**SUBJECT: APPROVAL OF REVISED WORK PLAN FOR ADDITIONAL
GROUNDWATER ASSESSMENT**

Re: Further Revised Down-Gradient Groundwater Assessment Work Plan, Fountain-Vine Plaza, 1253 N. Vine Street, Los Angeles, California 90028, LARWQCB SLIC No. 1196, Global ID SL0603734628

**SUBJECT: RESPONSE TO A REQUEST FOR THE FURTHER REVISED WORK PLAN
EMAILED ON FEBRUARY 18, 2014**

Re: 1253 N. Vine Street, Hollywood, CA (Fountain-Vine Plaza) and 1300-1310 Vine Street, Hollywood, CA (Paragon Cleaners) - Request for Approval of Workplan or Alternatively, Issuance of No Further Action Letter For Fountain-Vine Plaza

Figure X: Proposed Monitoring Well Location Map
 Fountain-Vine Plaza
 1253 Vine Street
 Los Angeles, California 90028

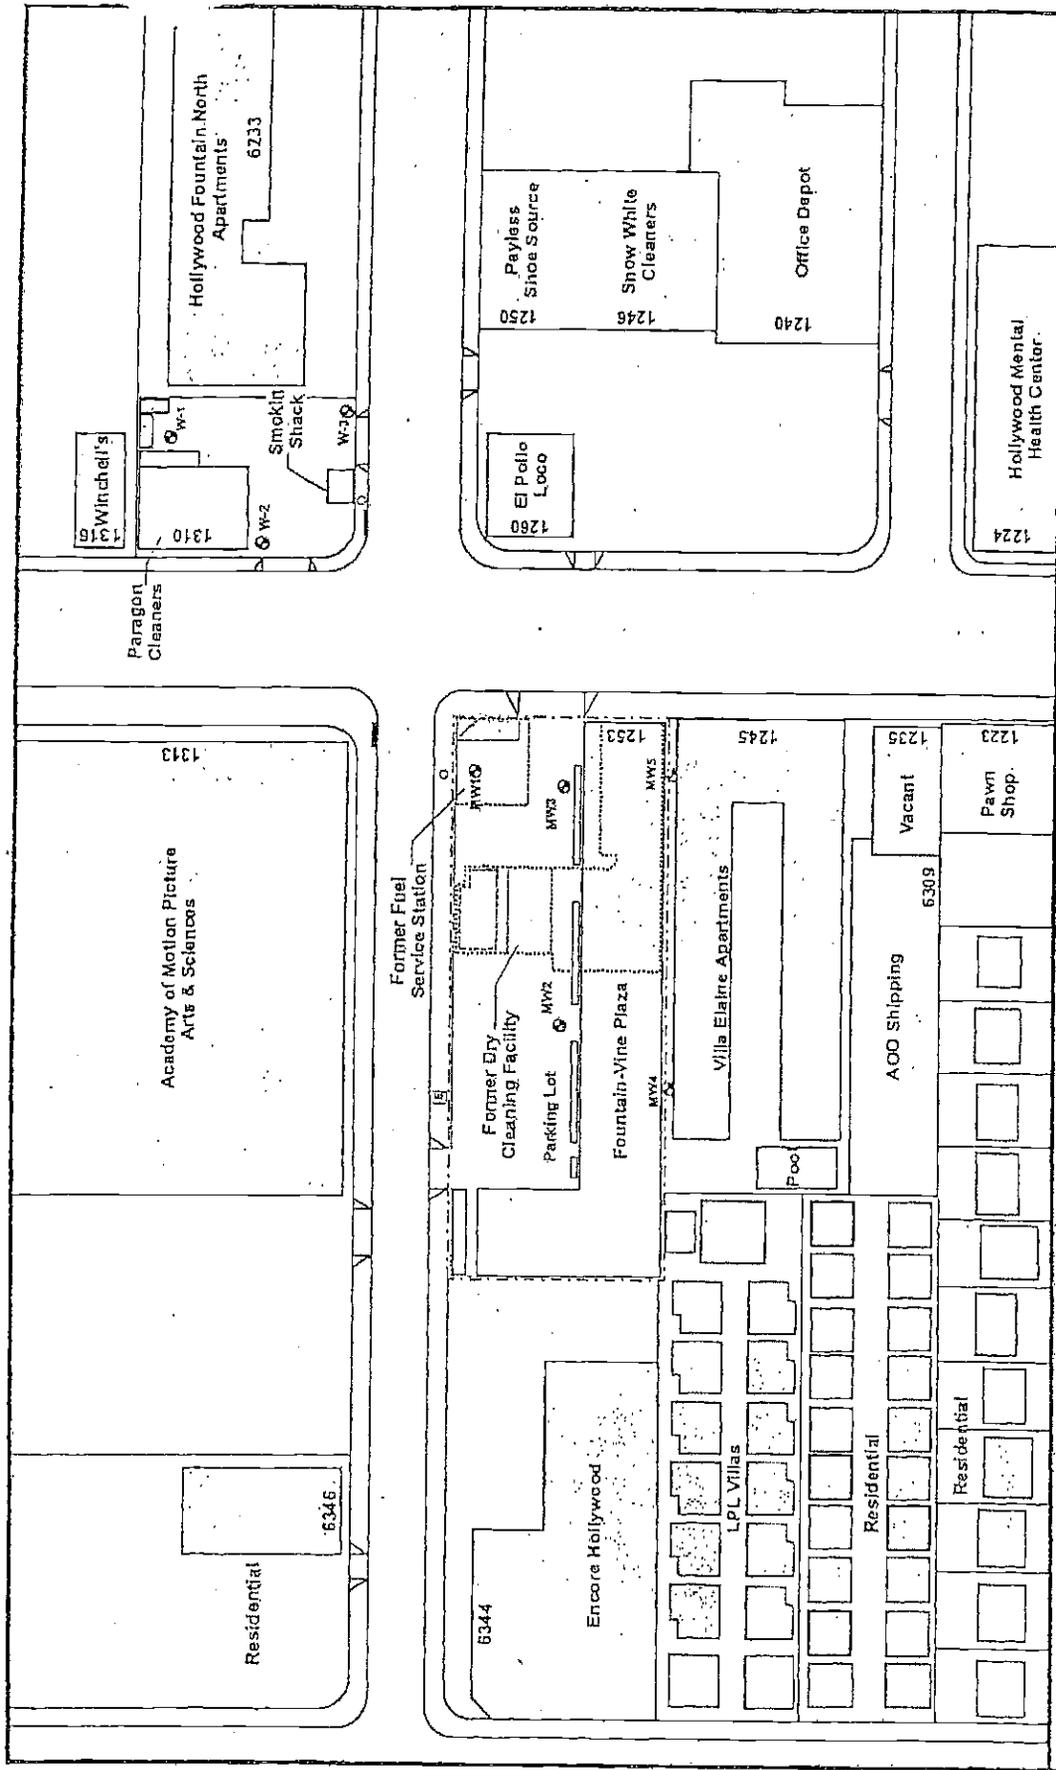
The work plan proposes the installation of two (2) groundwater monitoring wells (MW-4 and MW-5) located within the Villa Elaine apartment complex, immediately south of the site (Figure 1). Groundwater will then be sampled from eight (8) groundwater monitoring wells located at the site, at the Villa Elaine apartments, and at Paragon Cleaners (located northeast of the site). Groundwater samples will be analyzed for volatile organic compounds (VOCs) and total petroleum hydrocarbons – gasoline range (TPHg).

On January 28, 2014, Mr. Ami Adini informed the Regional Board that the work plan may be further revised based on structural information that is being provided to him by Ms. Patten. Since the Villa Elaine Apartments is a historical site, there are some restrictions to drilling. If the location of the groundwater monitoring wells, or the number of the groundwater monitoring wells are modified beyond what has been indicated in the work plan, then you shall inform the Regional Board and get written approval from the Regional Board before you begin installing the groundwater monitoring wells.

Based on information submitted, and on the information in the case file, we concur with the proposed work plan. A technical report shall be submitted electronically to the Regional Board documenting the installation of the groundwater monitoring wells by April 15, 2014. A groundwater monitoring report shall be submitted with the technical report and shall include an analysis of the data obtained from the eight groundwater monitoring wells.

Figure 3: Proposed Monitoring Well Location Map

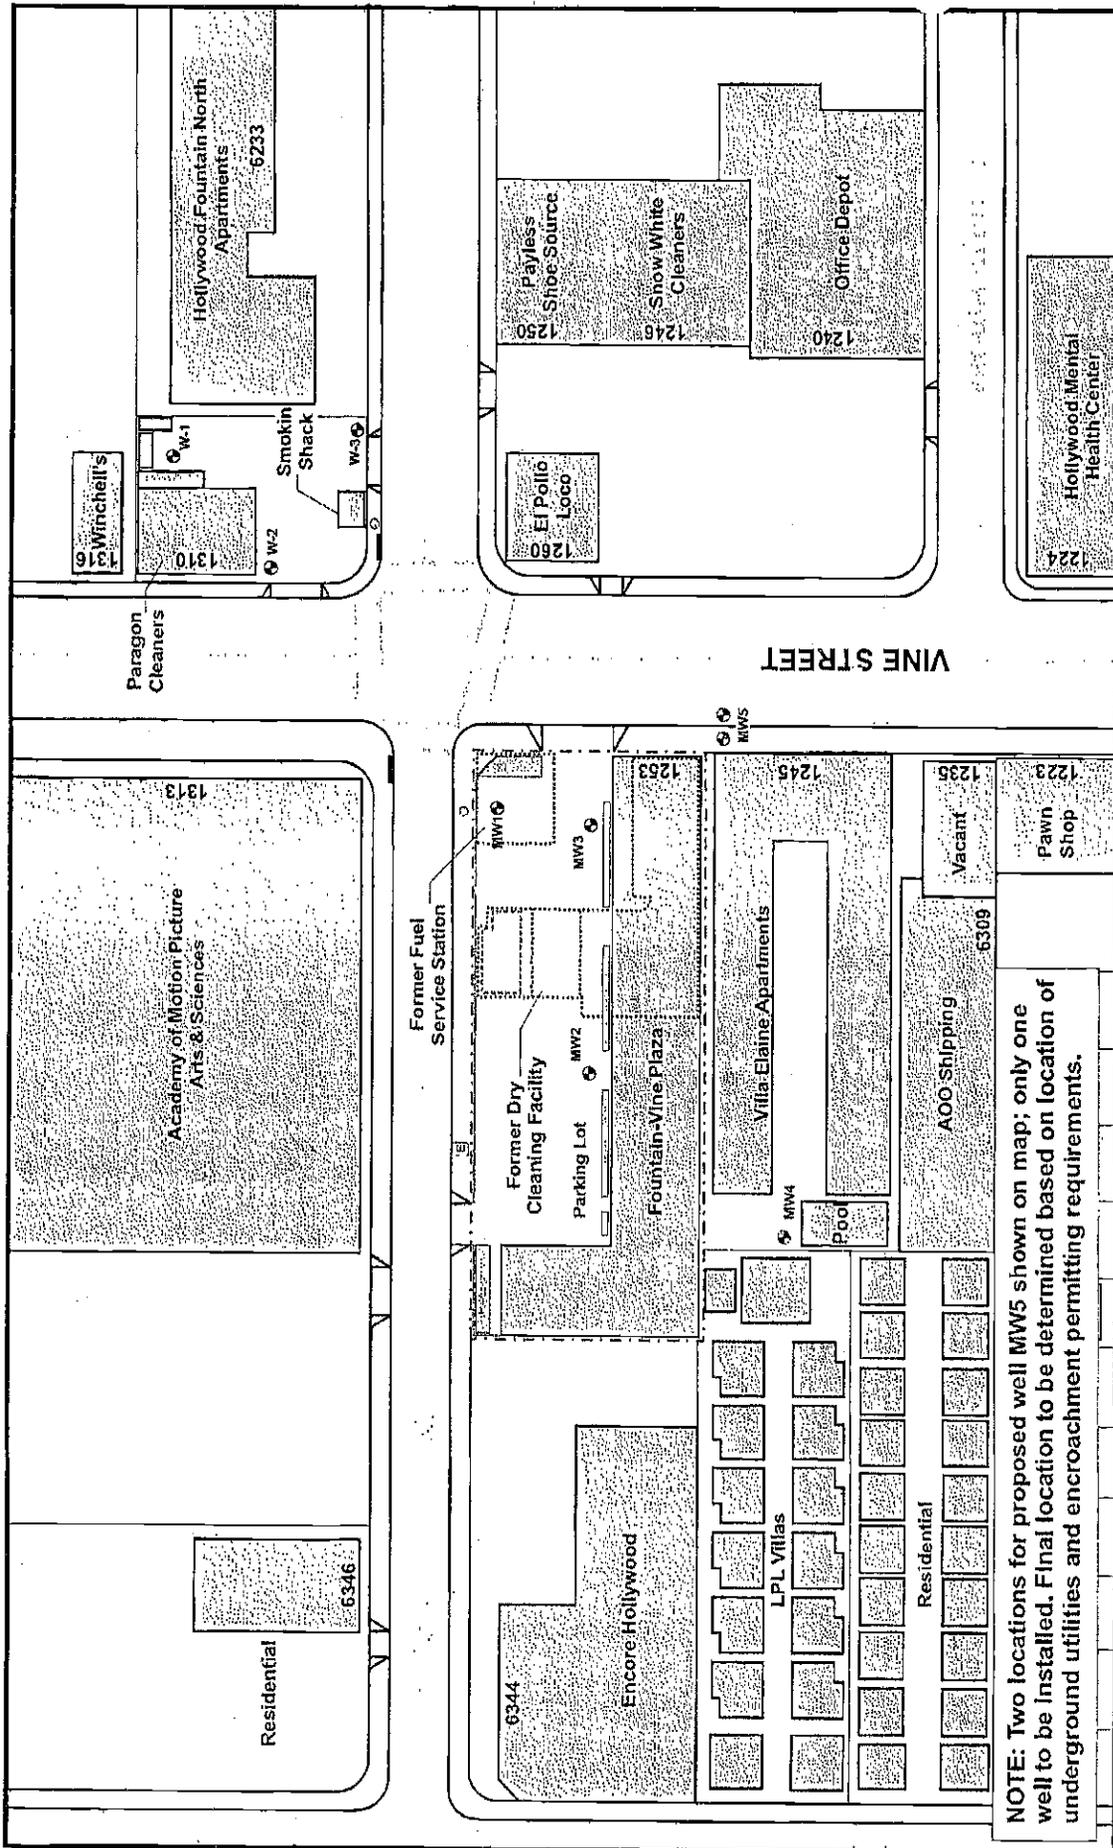
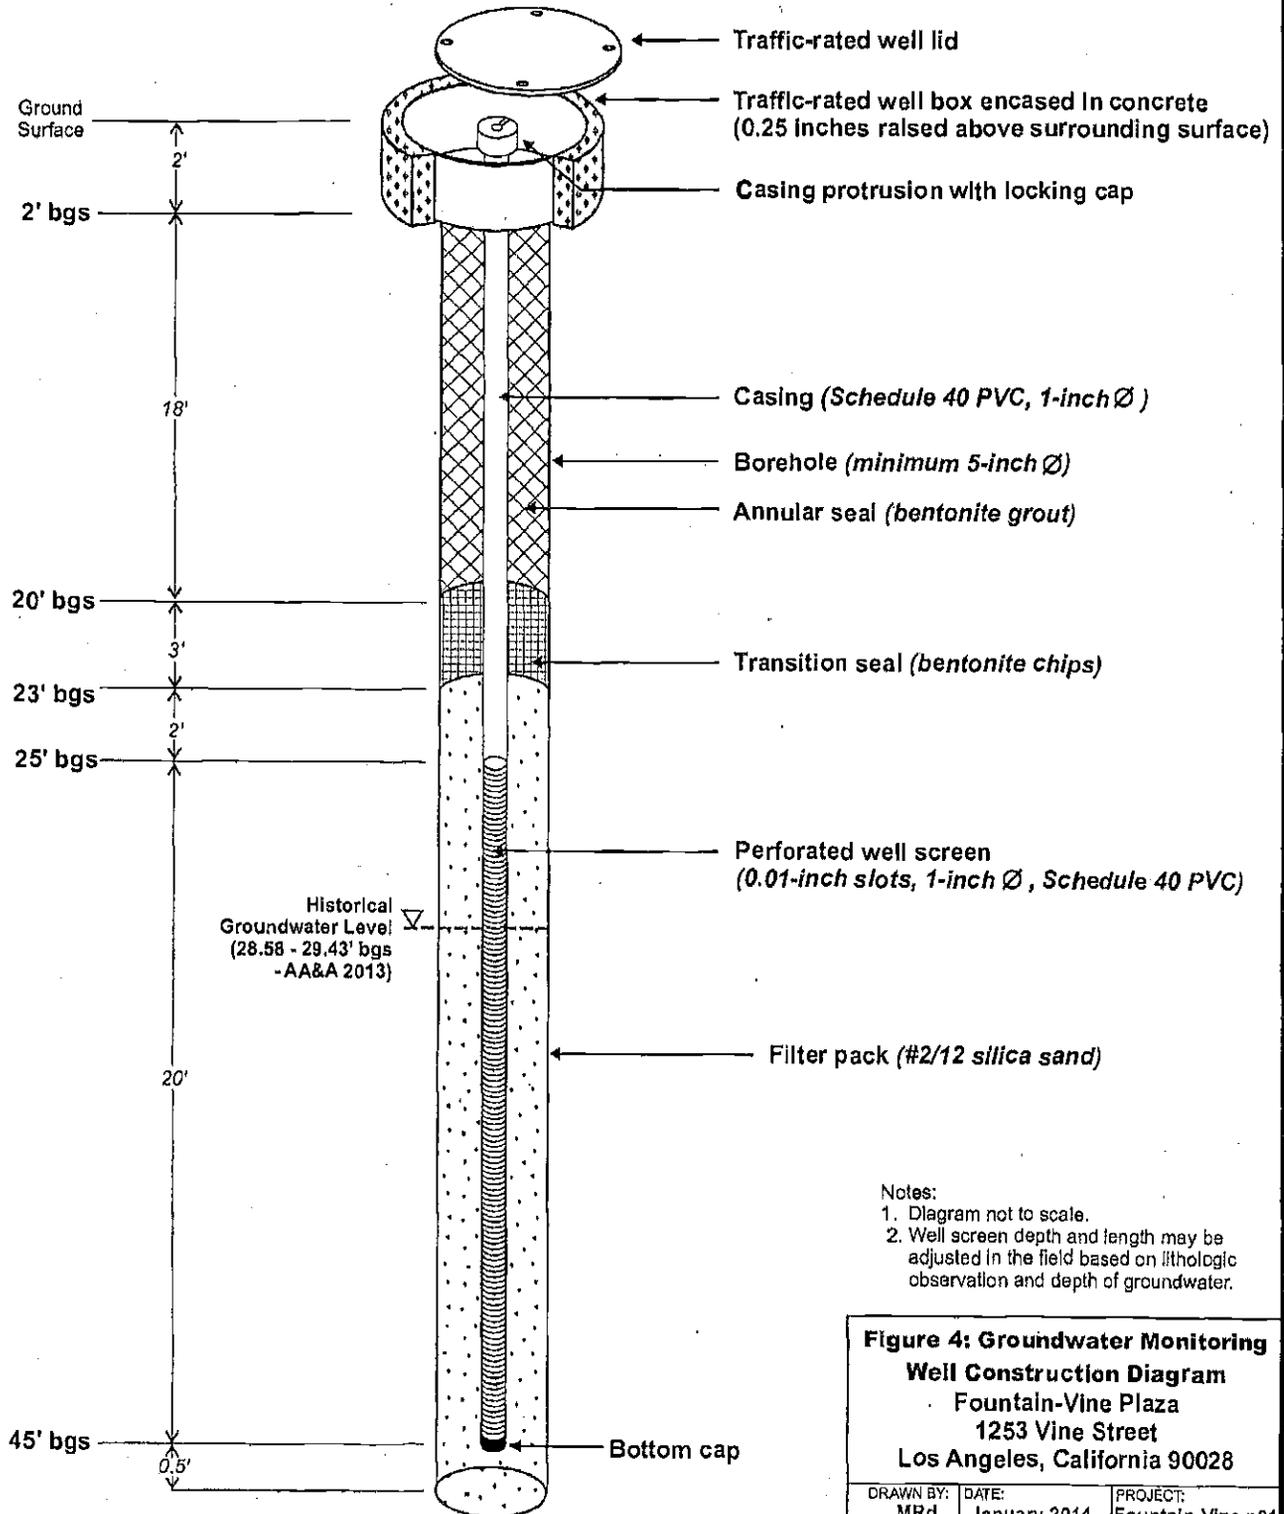
This further revised work plan involves the relocation of the two proposed groundwater monitoring wells MW4 and MW5. The initial *Revised Down-Gradient Groundwater Assessment Work Plan*, dated January 21, 2014 was submitted to the LARWQCB and subsequently approved in a letter dated February 6, 2014 (attached). The scope of work included in the revised work plan involved the installation and sampling of two groundwater monitoring wells, identified as MW4 and MW5 which were proposed to be installed in the alley/pathway at the northern border of the Villa Elaine Apartments apartment complex located adjacently south of the site.

Subsequent to the approval of the revised work plan, AA&A was informed by the Villa Elaine Apartments that the footing of the foundation extends four feet beyond the building and could not be cut or underpinned. Since the approved well locations in northern alley/pathway were no longer viable locations without affecting the integrity of the Villa Elaine Apartments, a site meeting was requested with representatives of the LARWQCB to discuss alternative well locations.

- Advance two off-site, hollow-stem auger borings from grade to approximately 45 feet below ground surface (bgs) as shown on revised Figure 3. Well MW4 is proposed to be installed in the vicinity of the abandoned swimming pool at the Villa Elaine Apartments at a minimum distance of 20 feet from the exterior wall of the building. Well MW5 is proposed to be installed in the sidewalk or parking lane near the northeast corner of the Villa Elaine Apartments at a minimum distance of 4 feet from the exterior wall of the building. The final location of well MW5 will be determined based on the locations of subsurface utilities and encroachment permitting requirements.

NOTE: Two locations for proposed well MW5 shown on map; only one well to be installed. Final location to be determined based on location of underground utilities and encroachment permitting requirements.

Figure X: Proposed Monitoring Well Location Map
 Fountain-Vine Plaza
 1253 Vine Street
 Los Angeles, California 90028
 DRAWN BY: LW/MRD DATE: January 2014 PROJECT: Fountain-Vine.p01

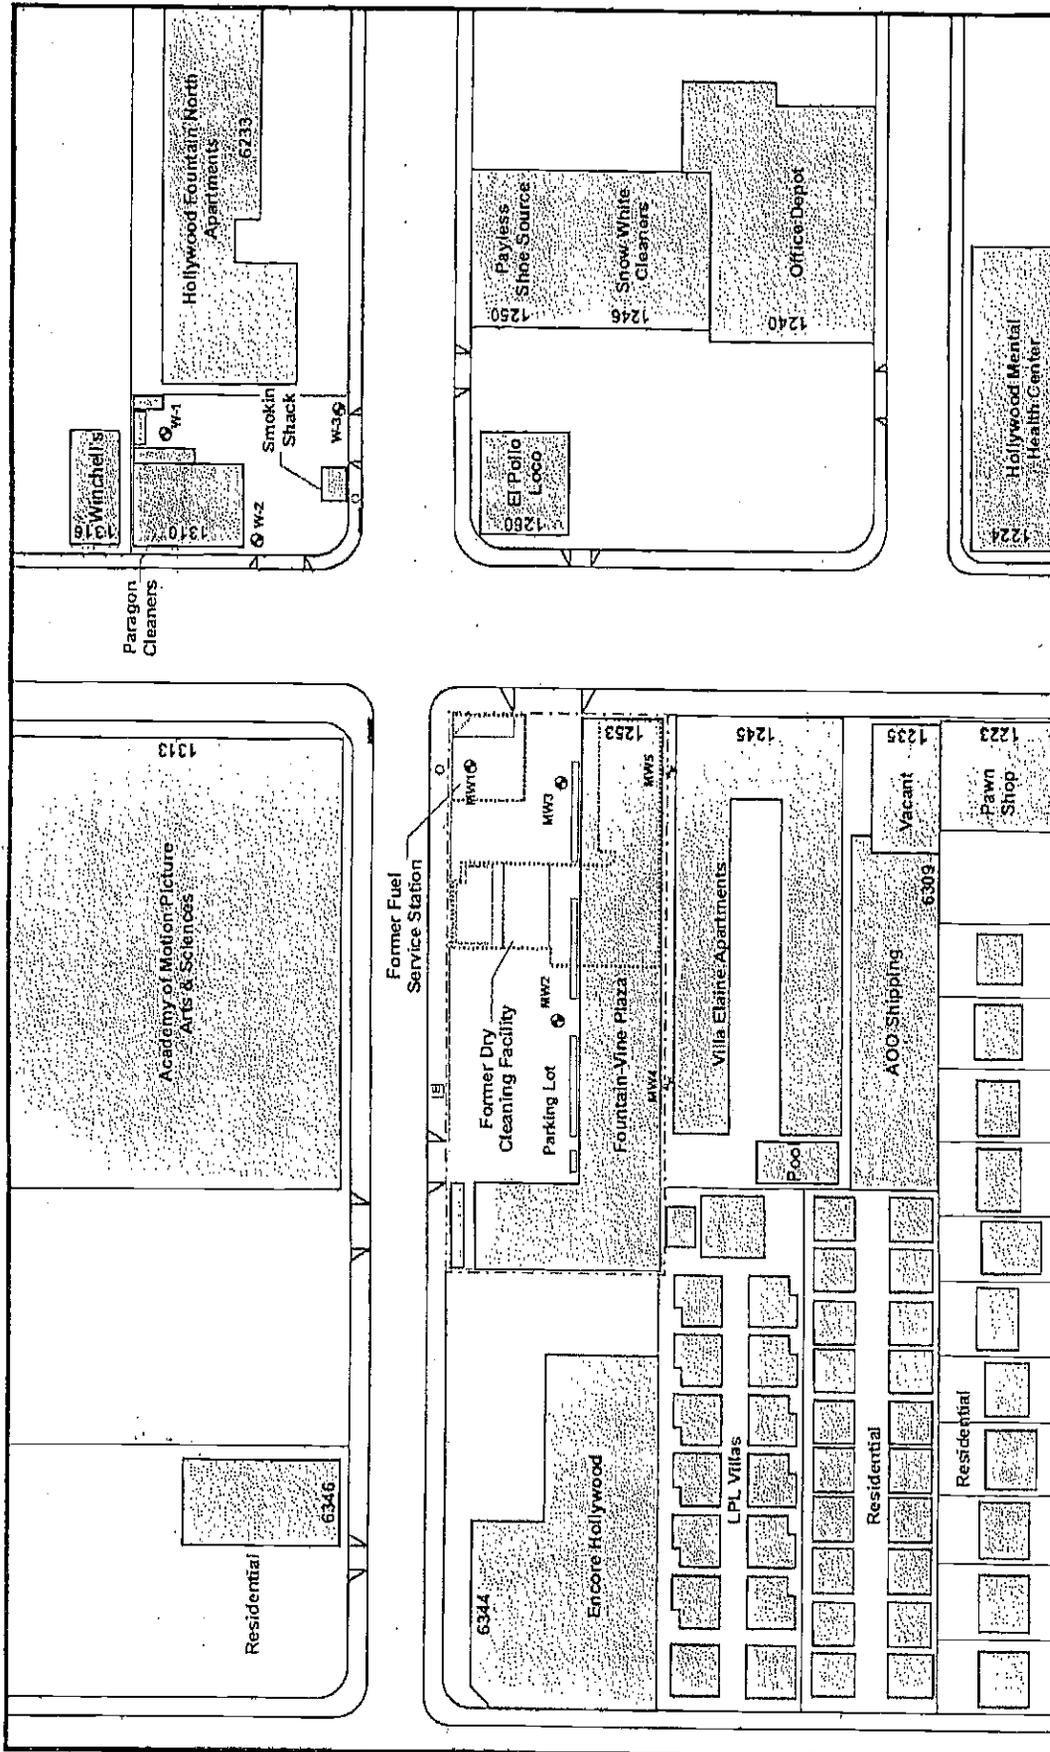
The work plan proposes the installation of two (2) groundwater monitoring wells (MW-4 and MW-5) located within the Villa Elaine apartment complex, immediately south of the site (Figure 1). Groundwater will then be sampled from eight (8) groundwater monitoring wells located at the site, at the Villa Elaine apartments, and at Paragon Cleaners (located northeast of the site). Groundwater samples will be analyzed for volatile organic compounds (VOCs) and total petroleum hydrocarbons – gasoline range (TPHg).

On January 28, 2014, Mr. Ami Adini informed the Regional Board that the work plan may be further revised based on structural information that is being provided to him by Ms. Patten. Since the Villa Elaine Apartments is a historical site, there are some restrictions to drilling. If the location of the groundwater monitoring wells, or the number of the groundwater monitoring wells are modified beyond what has been indicated in the work plan, then you shall inform the Regional Board and get written approval from the Regional Board before you begin installing the groundwater monitoring wells.

Based on information submitted, and on the information in the case file, we concur with the proposed work plan. A technical report shall be submitted electronically to the Regional Board documenting the installation of the groundwater monitoring wells by **April 15, 2014**. A groundwater monitoring report shall be submitted with the technical report and shall include an analysis of the data obtained from the eight groundwater monitoring wells.
